Addendum NO. 1

PROJECT: Phase 1 Part B
Wright Ave Jail
Date: July 28, 2025

A1B-7.1

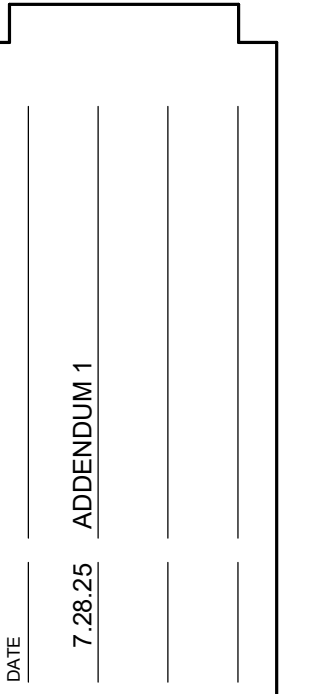
A1B-7.1 ADD Seismic Joints to Ceiling Grid and ADD seismic joint detail.

SITE PLAN
CIVIL ENGINEERING DRAWINGS
WRIGHT AVENUE JAIL PHASE 1-B
WRIGHT AVENUE
TWIN FALLS, IDAHO

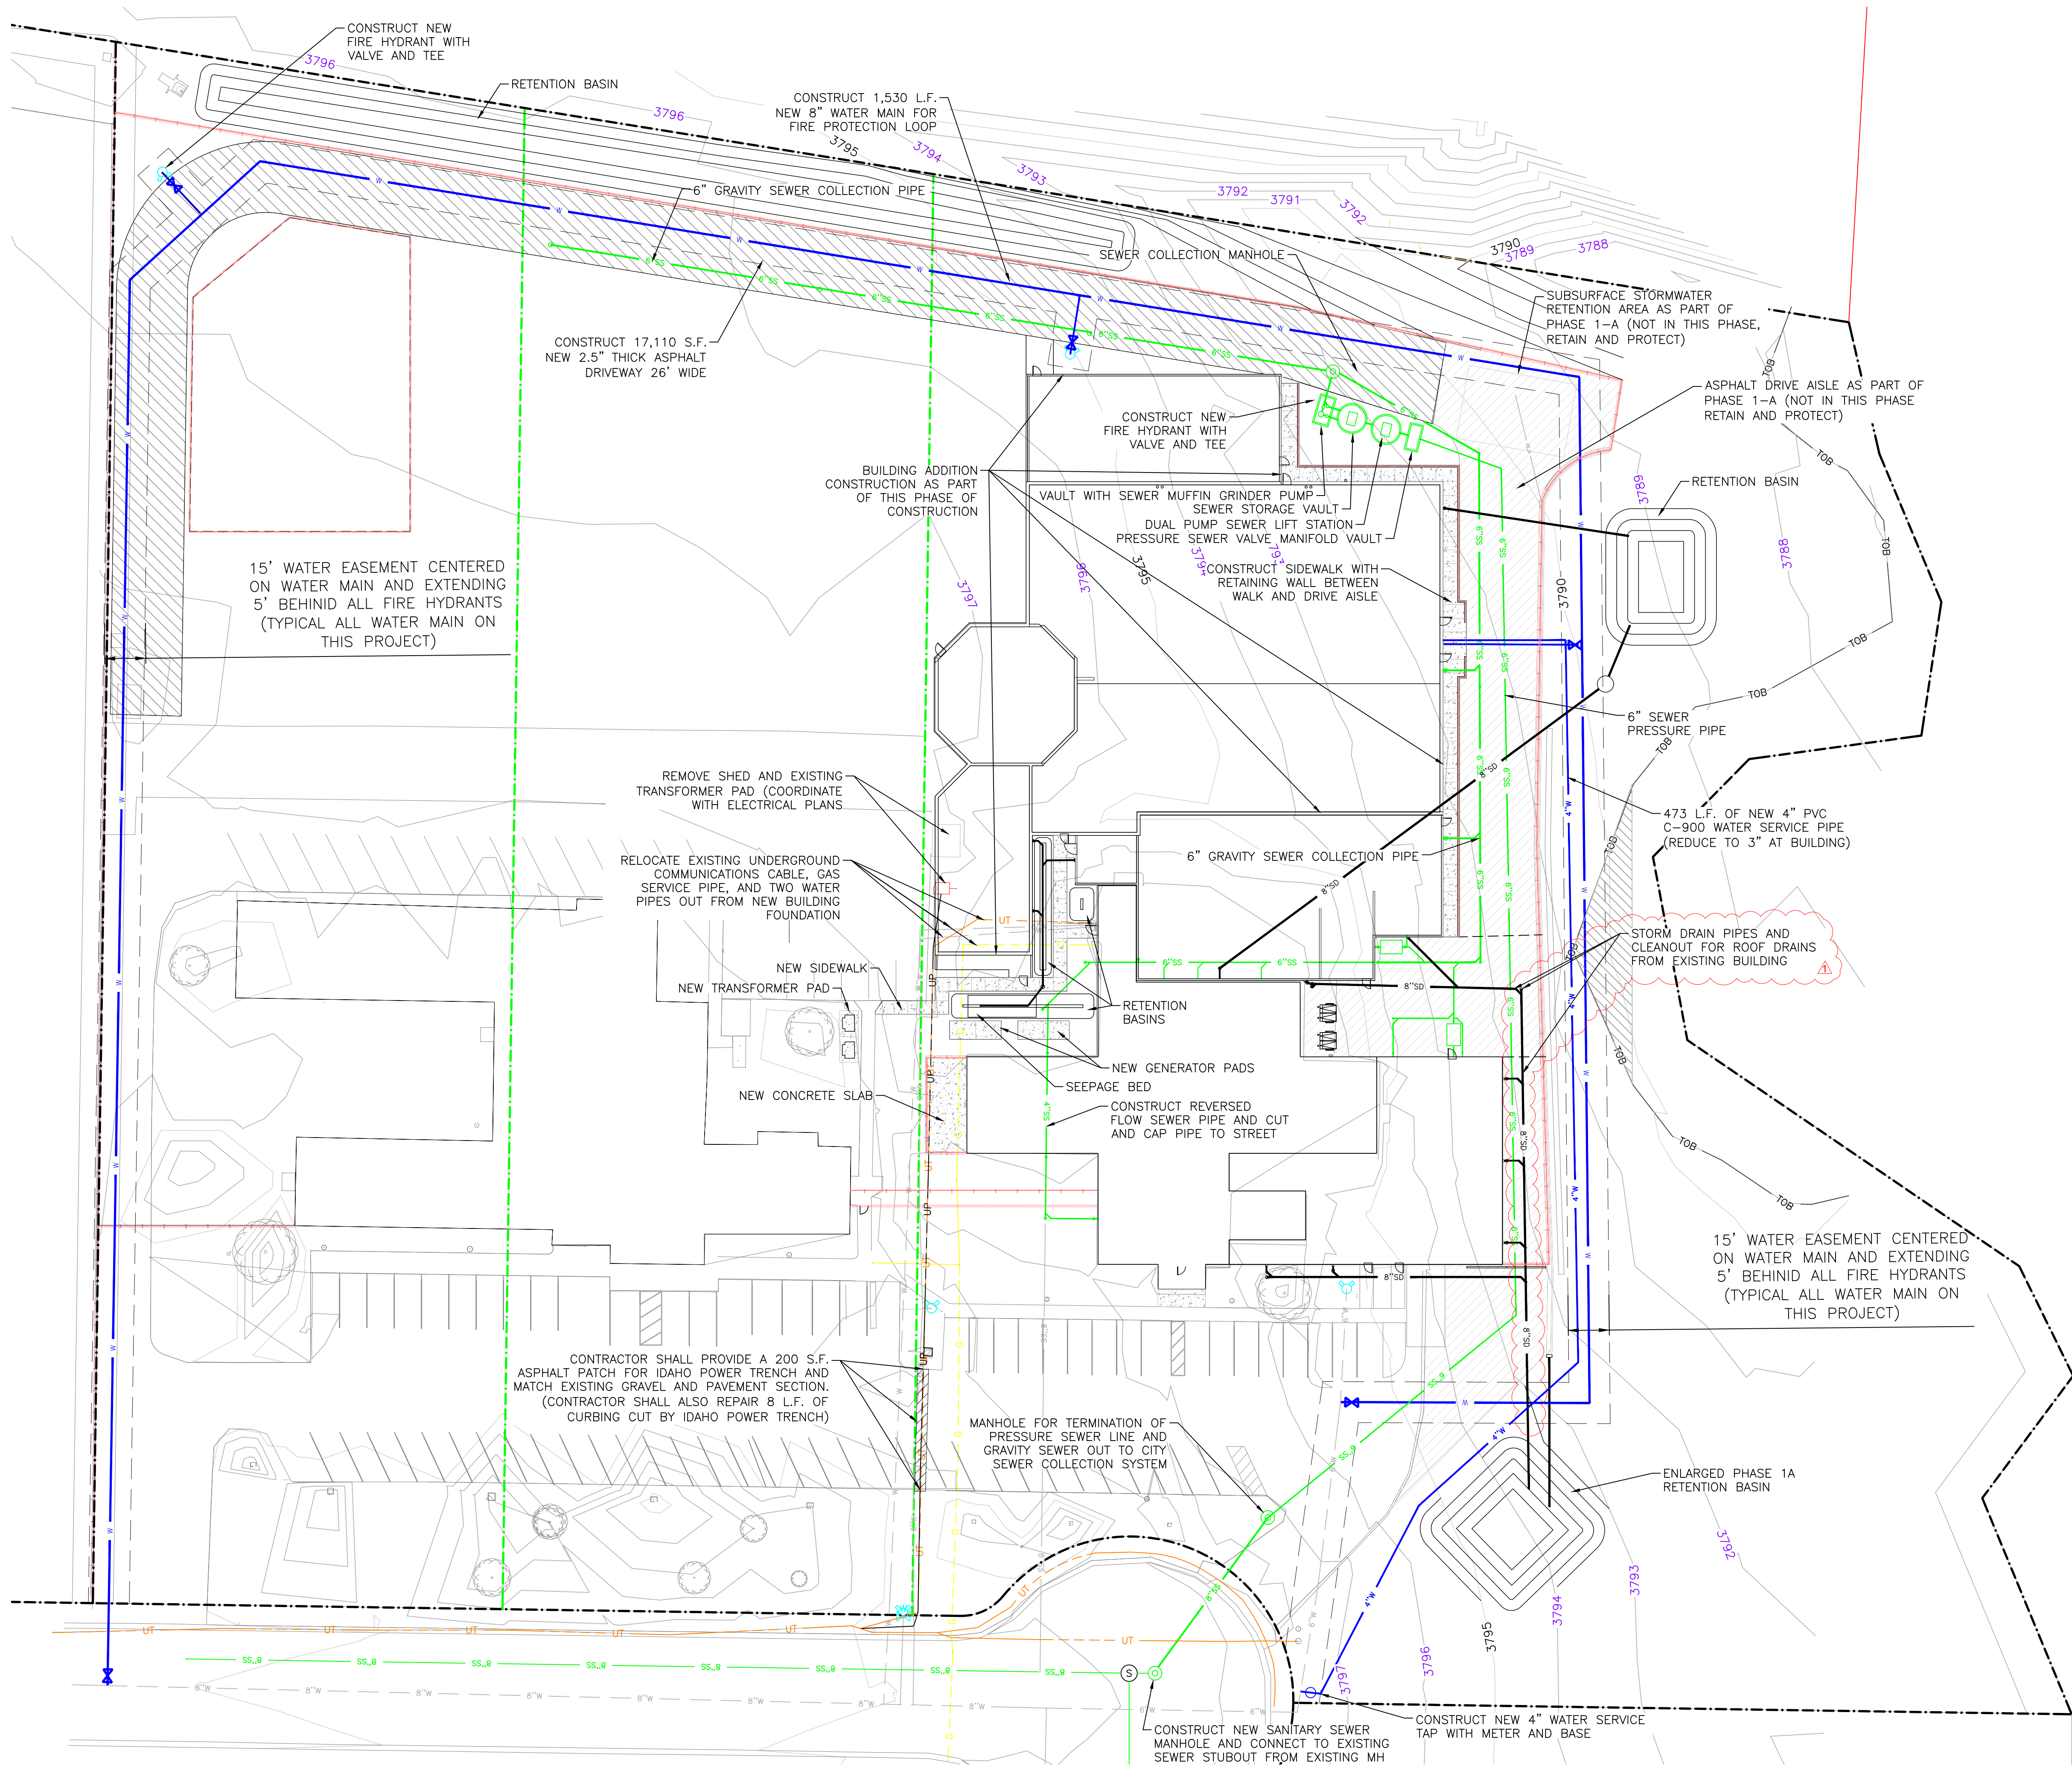
REPLACE C-1 and C-2

One storm drain curb inlet was removed from the project.

An 8" cleanout was added.

The stormwater roof drains from the existing building were shortened approximately 7'.

The 8" stormwater pipe running parallel to the retaining wall was moved approximately 8' toward the building to reduce the impact on the geotextile fabric and retaining wall structure.

The 8" storm pipe that used to be 132' in length is now approximately 183' in length and now terminates in the swale instead of the curb inlet box.
